UNITED STATES PATENT AND TRADEMARK OFFICE

10/709,675

Office Action Summary	Application No. 10/709,675	Applicant(s) CONRAD ET AL.	
	Examiner NICOLE BLAN	Art Unit 1792

DETAILED ACTION

Fig. 1: Refer to claims 30-31 above

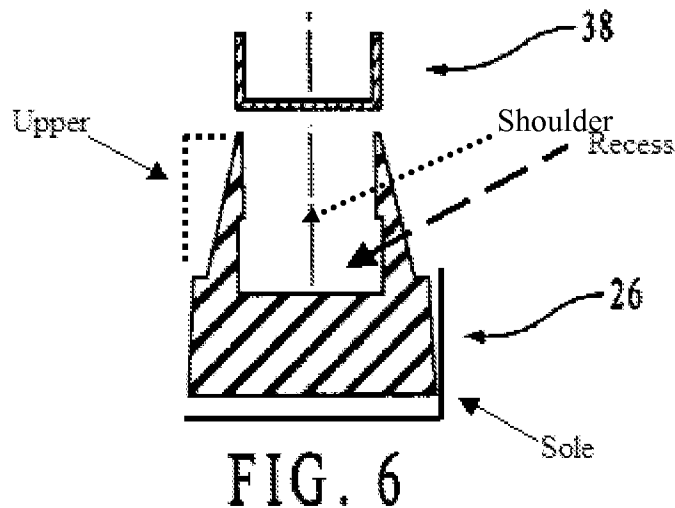
Claims 30-31, 4-5, 7: '944 teaches a household clothes washer [also referred to as a household appliance] [col. 1, lines 15-17] for use in a home environment having a floor [inherent trait of an appliance for use in a house] for supporting the household clothes washer [or appliance] comprising: a cabinet [(1), Fig. 1, col. 2, lines 47-48]; a wash basket [(6), Fig. 1, col. 2, lines 26-31] mounted within the cabinet for rotational motion [col. 2, lines 31-36] [the wash basket corresponds to a vibration generator located within the cabinet]; a foot [(15), Fig. 1, col. 2, lines 63-64] extending from the cabinet for supporting the cabinet on the floor; and a boot mounted to the foot [(23), Fig. 1, col. 3, lines 1-3]. '944 also teaches that the boot is made from an elastomeric material [col. 3, lines 13-44].

'944 does not teach an upper defining a foot recess in which the foot is removably received to couple the boot to the foot, a sole in contact with the floor in isolating and non-isolating conditions, a snubber in contact with the floor in non-isolating conditions and out of contact with the floor in isolating condition, and a the boot is deformable. However, '998 teaches a solid-body boot [refer to Fig. 1 below, reference number 26] and that a foot is capable of being removed from the boot [col. 1, lines 43-54]. '998 also teaches a sole configured to be in contact with the floor [see Fig. 1 below as well as Figs. 3-5 in the prior art] and that the boot is deformable [see Fig. 5 in the prior art]. It would have been obvious to one of ordinary skill in the art at the time the invention was made to have used the removable boot of '998 as the

'944 and '998 do not teach a snubber in contact with the floor in non-isolating conditions and out of contact with the floor in isolating condition, and that a boot is deformable between a first physical shape when the snubber is out of contact with the floor and a second physical shape when the snubber is in contact with the floor. However, 405 teaches a sole [abstract] with a snubber [lug, pg. 2, paragraph 28, lines 1-3] [(31), Figs. 3A and 3B, pg. 3, paragraph 38, lines 3-5] out of contact with the floor [Fig. 3A, pg. 2, paragraph 27, lines 4-7] and in contact with the floor [Fig. 3B, pg. 2, paragraph 27, lines 7-13 and pg. 3, paragraph 38, lines 5-14] so as to isolate the force created to prevent walking [slipping, pg. 3, paragraph 38, lines 11-14]. It would have been obvious to one of ordinary skill in the art of isolating forces that the sole as taught by '405 could be used as the sole of '998 with a reasonable expectation of success because '405 teaches that it isolates force and prevents slipping. This also reads on claim 7.

The modified boot of '998 and '405 teaches that the boot is deformable such that the snubber moves relative to the foot as the boot is deformed between a first physical shape corresponding to the isolating condition/natural state [reads on claim 4], where the snubber is out of contact with the floor [reads on "spaced above the floor" in claims 5 and 23] and the boot substantially isolates the floor from forces generated by the rotation of the basket and acting through the foot [Fig. 3A, pg. 2, paragraph 27, lines 4-7], and a second physical shape corresponding to the non-isolating condition/collapsed state [reads on claim 4], where the snubber is in contact with the floor [reads on "compressed against the floor" in claims 5 and 23]

and the boot substantially passes forces through the foot and into the floor [Fig. 3B, pg. 2, paragraph 27, lines 7-13 and pg. 3, paragraph 38, lines 5-14]. Therefore, it would have been obvious to one of ordinary skill in the art at the time the invention was made to use the modified boot combination of '998 and '405 as the boot of '944 with a reasonable expectation of success because '998 and '405 teach that shock absorbing fixtures are used to isolate forces.

Figure 2: Refer to claim 22

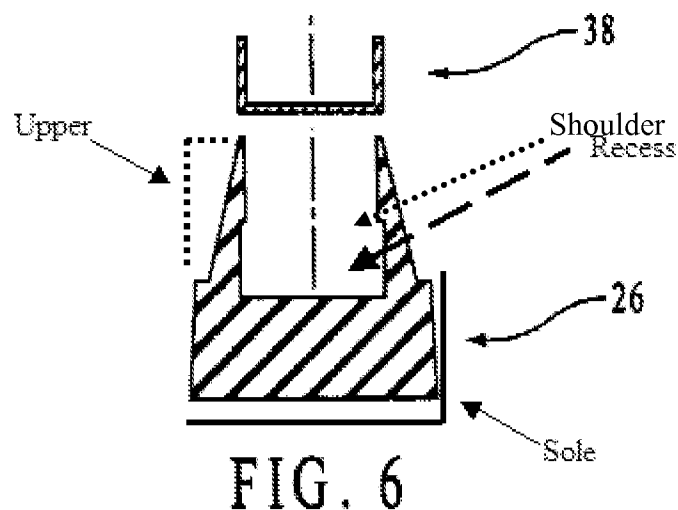
Claim 22: '944, '998, and '405 teach the limitations of claim 31 above. '998 also teaches a boot [(26), Fig. 6, col. 3, lines 52-55] comprising a sole with a bottom surface for contacting the floor [see Fig. 6 below, the bottom portion of (26)], and an upper extending from the sole [see Fig. 6 below, the upper portion of (26)] and defining a foot recess [see Fig. 6 below, the inner portion of (26) is the recess] in which the foot [(38), Fig. 6] is received to mount the boot to the foot in order to isolate the forces generated by the appliance. Refer to Figure 2 below.

Figure 3: Refer to claim 10

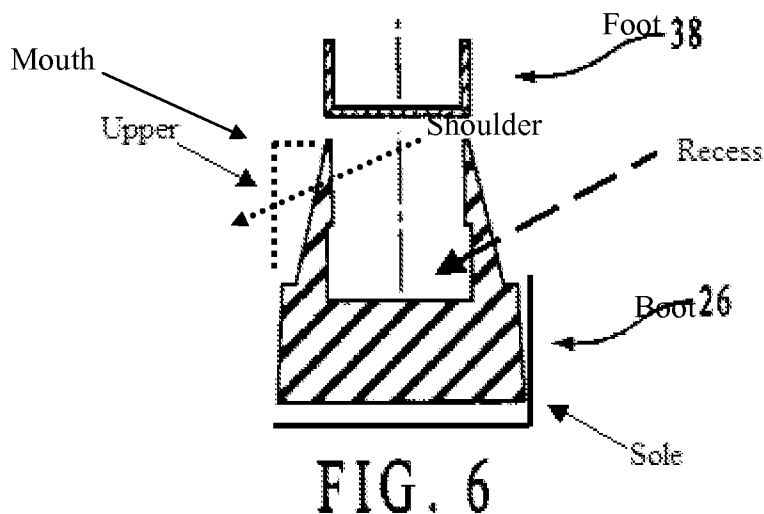
Claim 10: '944, '998, '405, and '345 teach the limitations of claim 8 above. '998 also teaches a washer according to claim 9, wherein the upper [see Fig. 3 below, the upper portion of (26)] terminates in a resilient shoulder [see Fig. 6 below] defining a mouth [see Fig. 6 below] for the foot recess [see Fig. 6 below, the inner portion of (26) is the recess], with the mouth having a portion smaller than the foot such that when the foot passes through the mouth, the resilient shoulder is initially deflected and when the foot is received in the recess, the resilient shoulder overlies a portion of the foot to aid in mounting the boot to the foot. See Figure below. It would have been obvious to one of ordinary skill in the art of isolating force that the boot as taught by '998 could be used as the boot of '944 since, '998 teaches that it is a shock absorbing fixture.
